**EXHIBIT C**  
**10.22.2021**

HOH Project # 5422:

2021-F326-REN CIP- Lakeview Health Center Renovations

Project Address: 2849-61 N. Clark St., Chicago Illinois

Pic 1, 2, 3 & 4: Sample boxes to be removed and reinstalled to side panel.

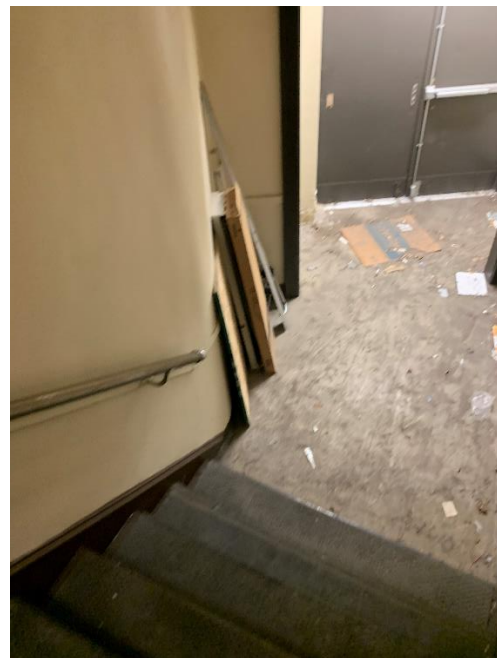
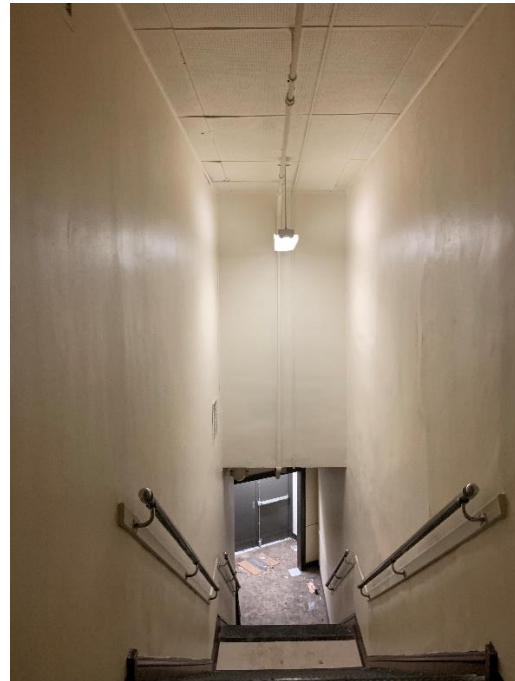
1. Sample boxes at the entry present a protruding object hazard and should be relocated.

**Recommendation:** Final location to be coordinated. Immediate removal is recommended to avoid potential injury since they are in the path of travel in and out of the facility.

Pics 9, 10, 11 & 12: First floor restrooms' plumbing fixtures to be removed and replaced per ADA requirements.

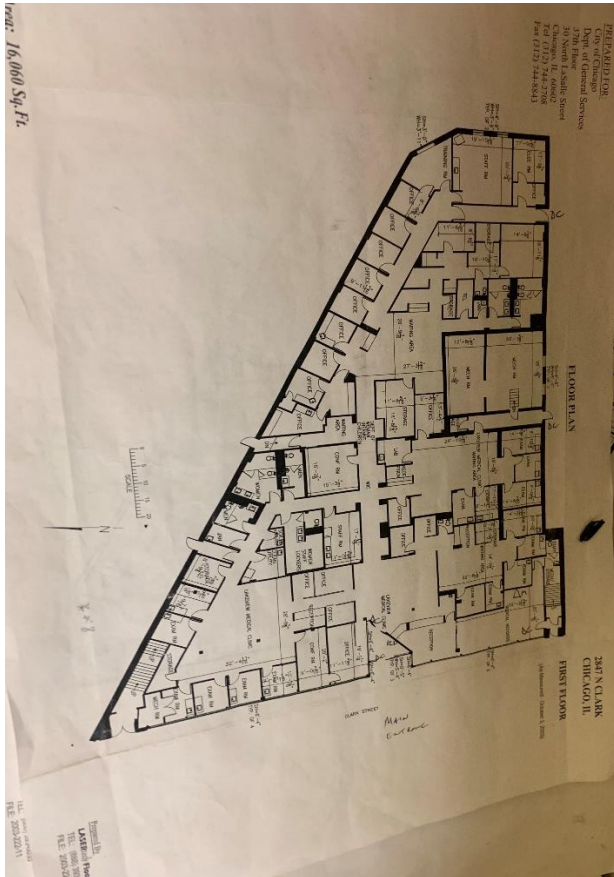
3. Upgrade plumbing fixtures in first floor toilet rooms to provide greater accessibility.

Recommendation: New first floor restrooms' layout and new plumbing fixtures and accessories to comply with ADA requirements. New finishes shall be installed after removal of existing restroom plumbing fixtures and existing finishes. 2 Men, 2 Women, 1 Staff and 2 single ADA restrooms were observed.

Pics 15 & 16: The shingles on the mansard roof shall be removed and replaced.

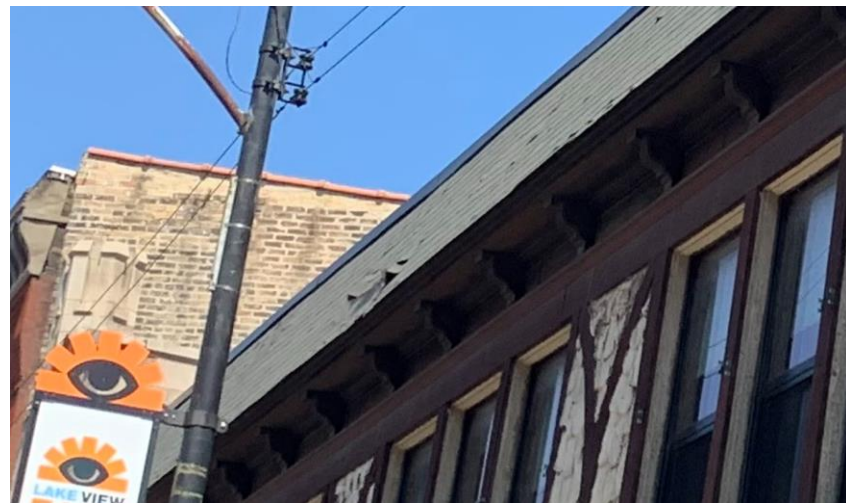
1. The asphalt shingles on the mansard roof were observed to be loose and in danger of falling off. Replace asphalt shingles and underlayment.

Recommendation: The shingles along Clark Street elevation must be removed and replaced in kind.

Remove and Replace asphalt shingles and underlayment including all accessories related to Clark St elevation.

Pics 21, 22, 23 & 24: Interior panic hardware needs to be assessed by door and security consultant to deem if appropriate or in need of replacement. A total of 3 doors facing Clark St, 2 doors facing the alley and 2 at the setback facing the neighbor at the south side of building.

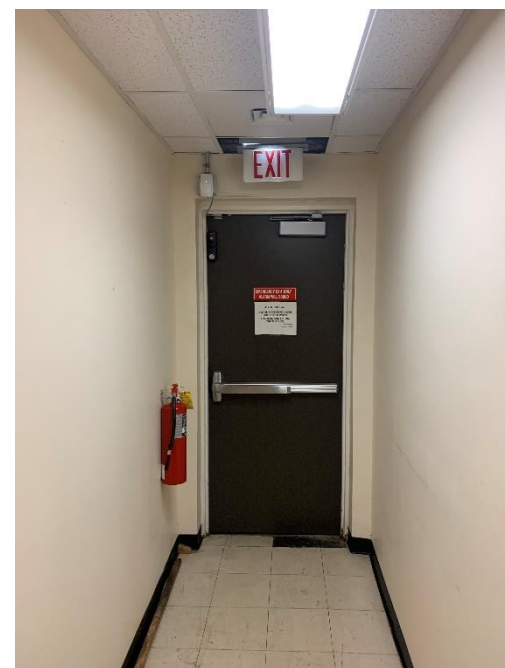
1. Provide proper panic hardware at all exit doors.

Recommendation: All exit doors were photographed but they need to be tested for proper functioning. AOR and door security consultant to test every one of the exit doors with their exit panic hardware for compliance.

Pics 25 & 26: show the locations for exit doors for first and second floors.

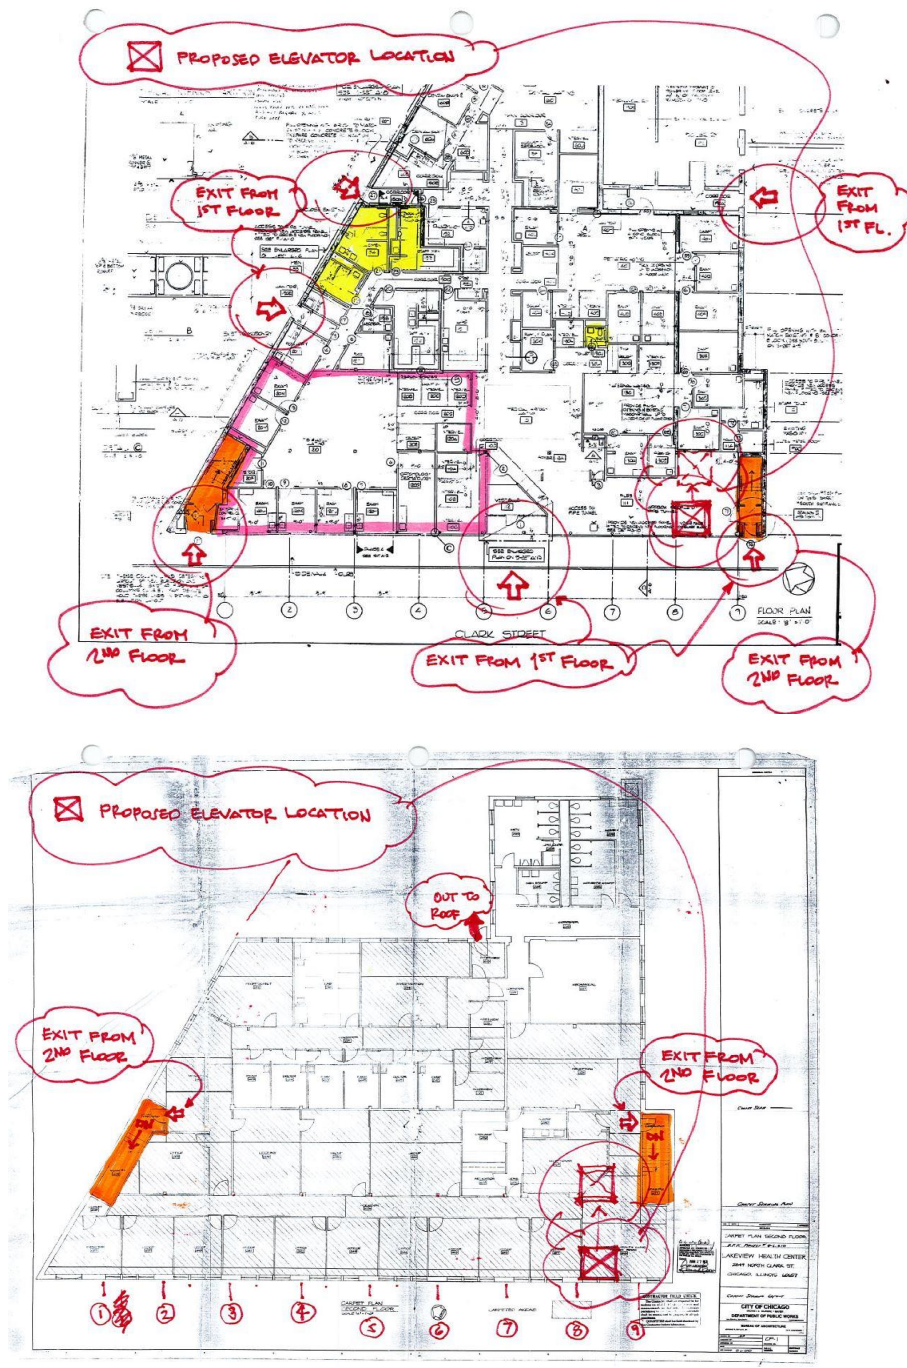
Pics 25 & 26: Show suggested location for elevator close to south staircase. This location seems to be most appropriate because it will need the least amount of disturbance to the facility's two levels.

An elevator consultant with KONE elevators has been contacted to give a proposal based on the sketches 25 and 26. When we receive the information will share it with the team. The hydraulic elevator requested is a 2500 lb for 2 stories ADA compliant.

Recommendation: if budget allows the elevator shall be installed to make 2<sup>nd</sup> floor ADA accessible.
